Addendum 3

Webster High School – Band Room & Greenhouse Additions w/ Site Improvements

10/6/2022

TO: ALL OFFICIAL PLAN HOLDERS

C7.0

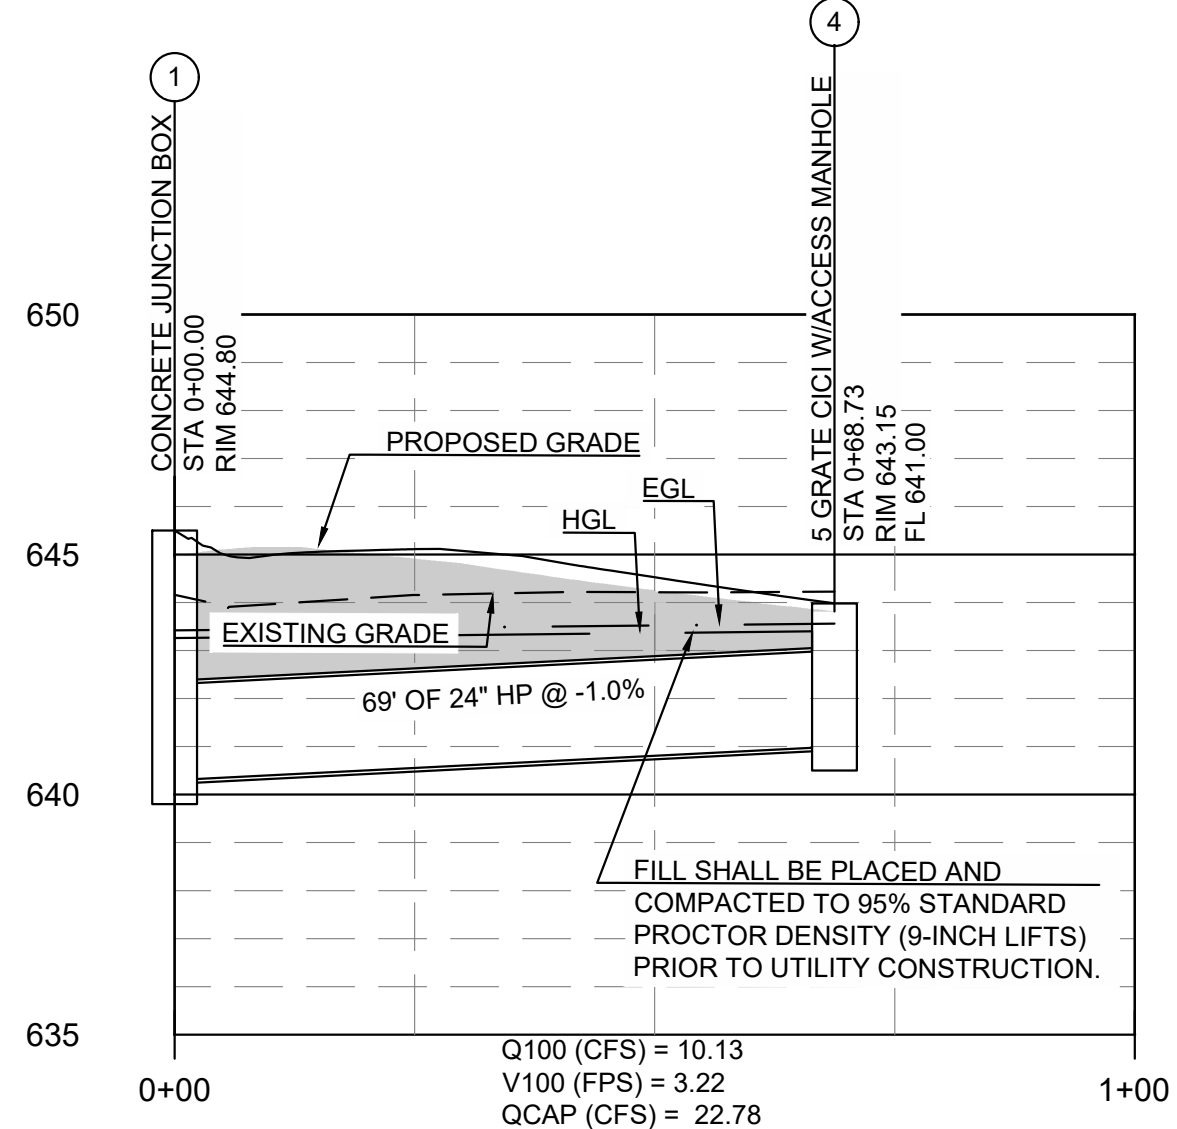
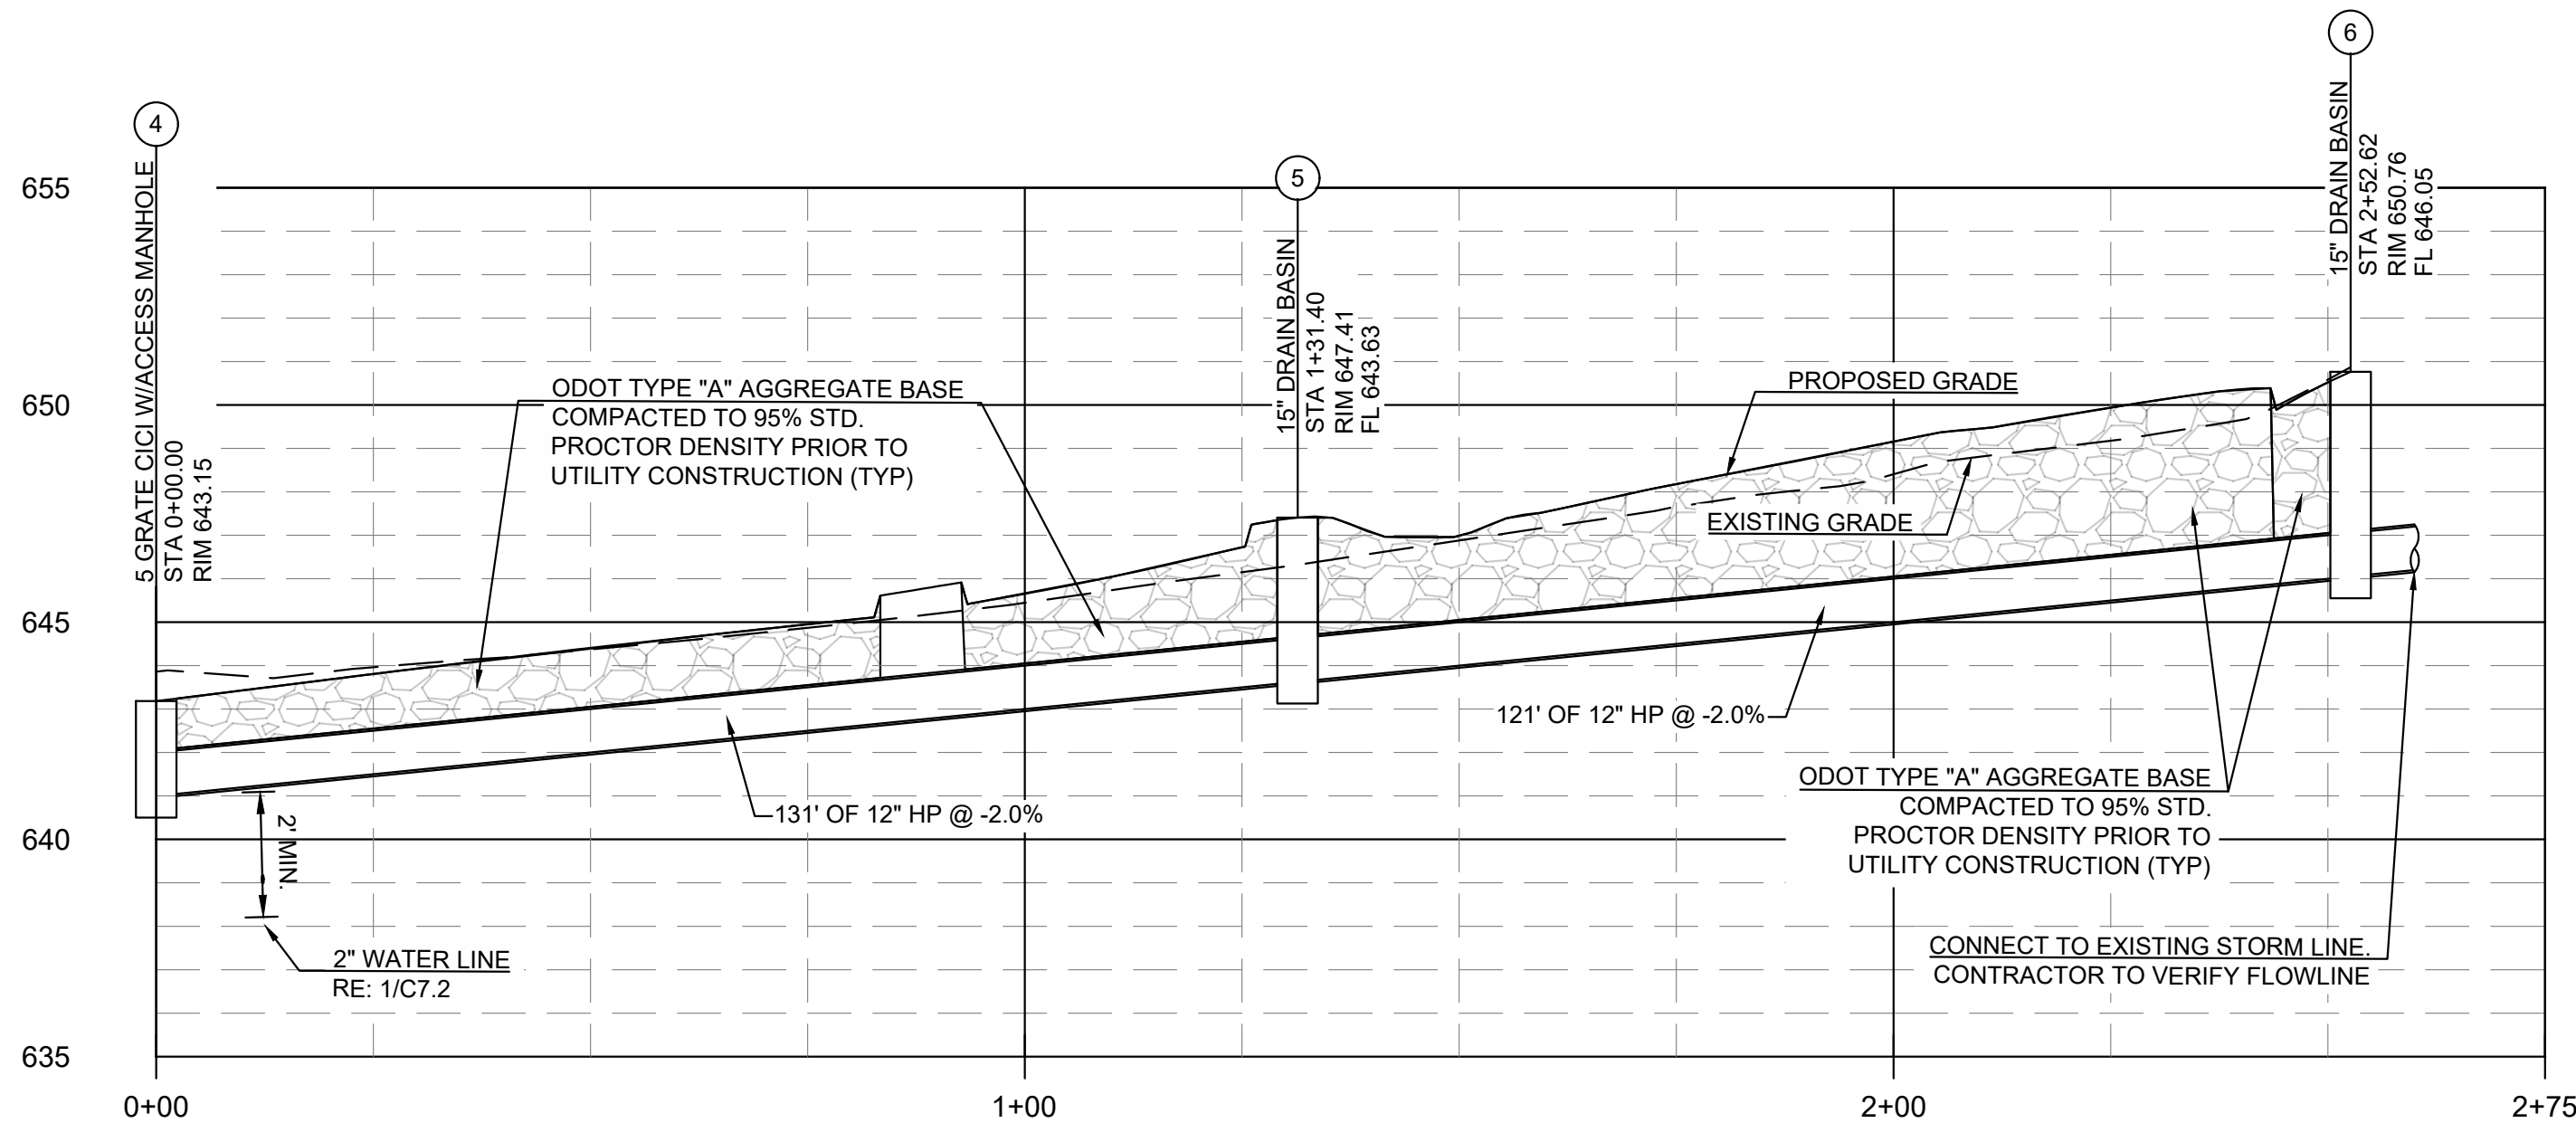
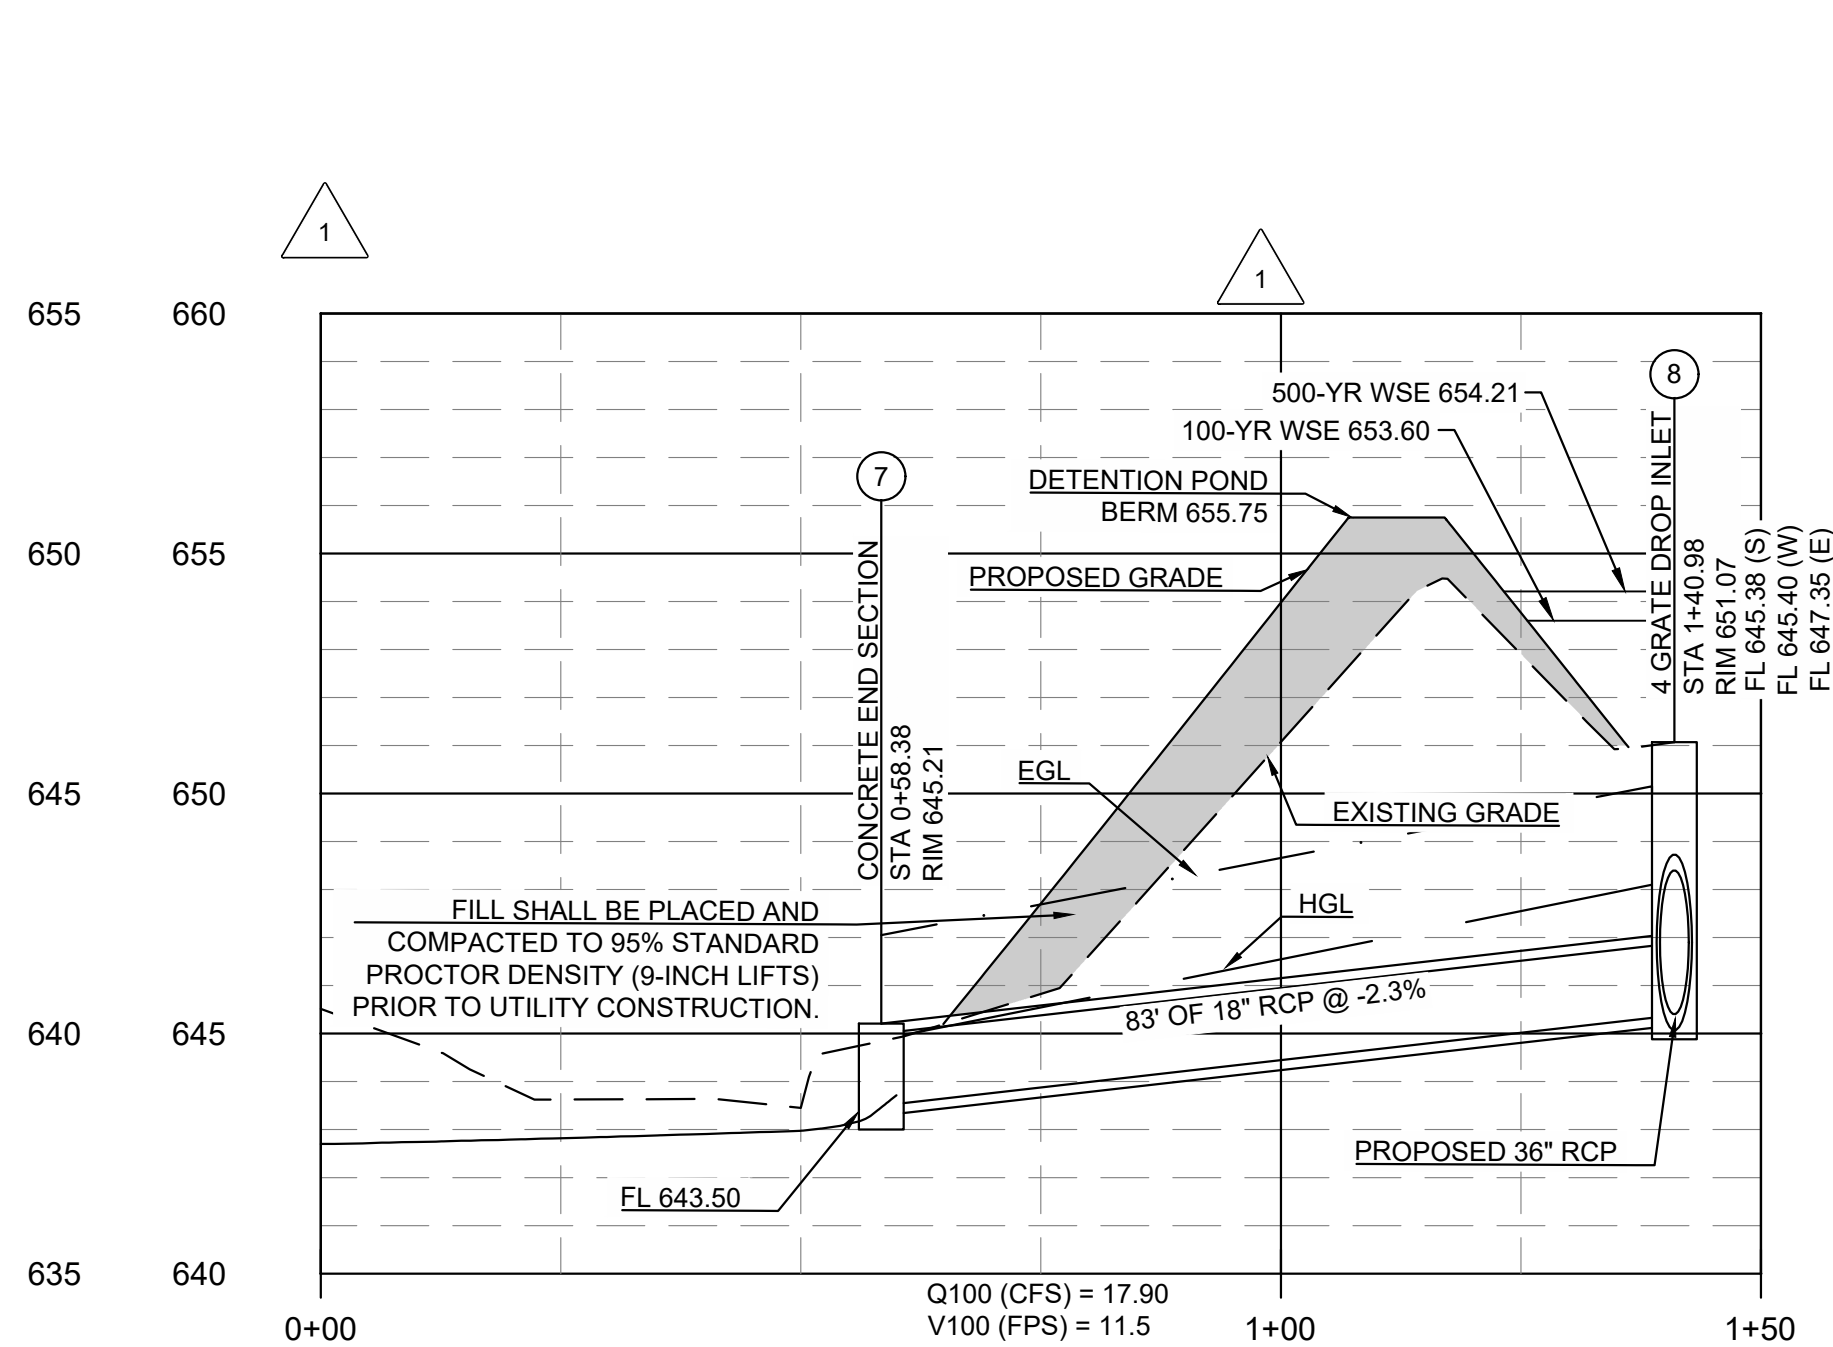
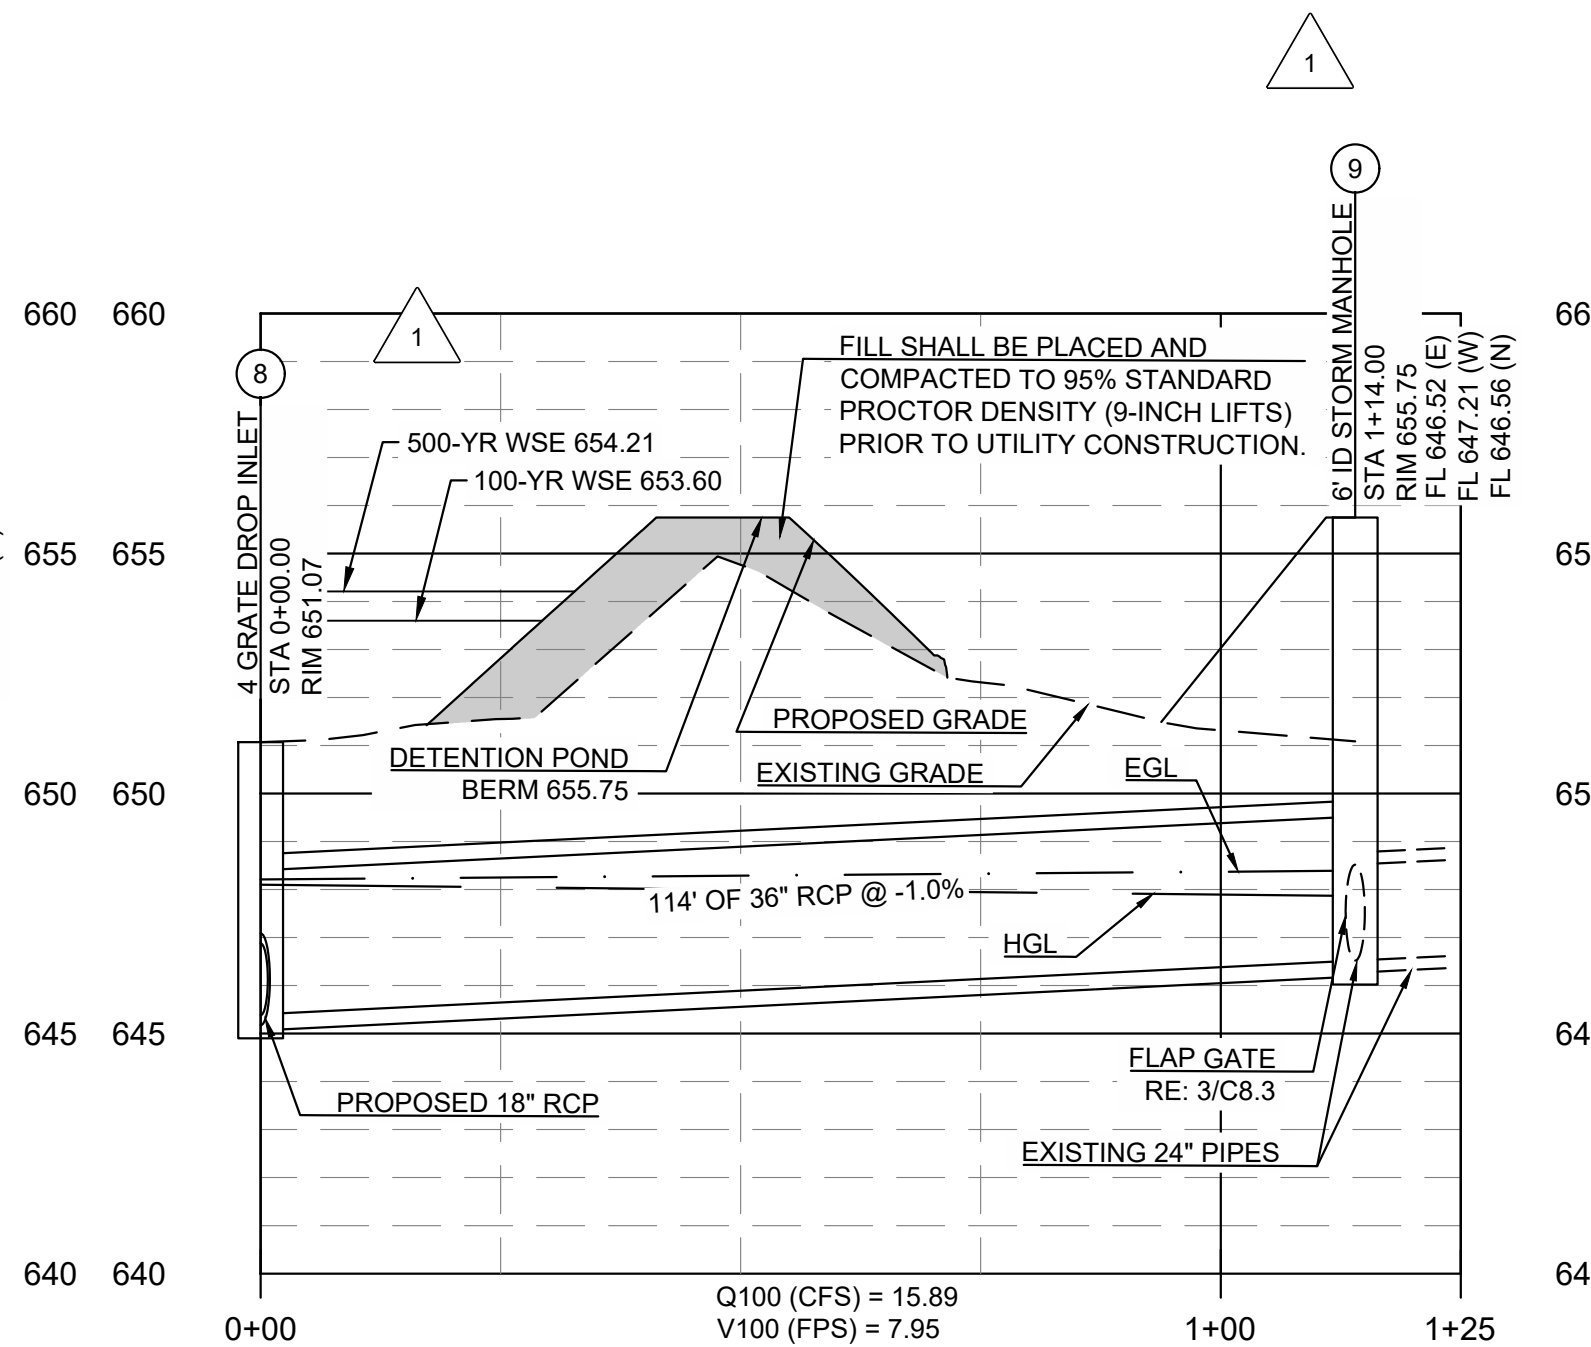
Item 1. Junction Box details removed from this sheet. (Added on C8.4)
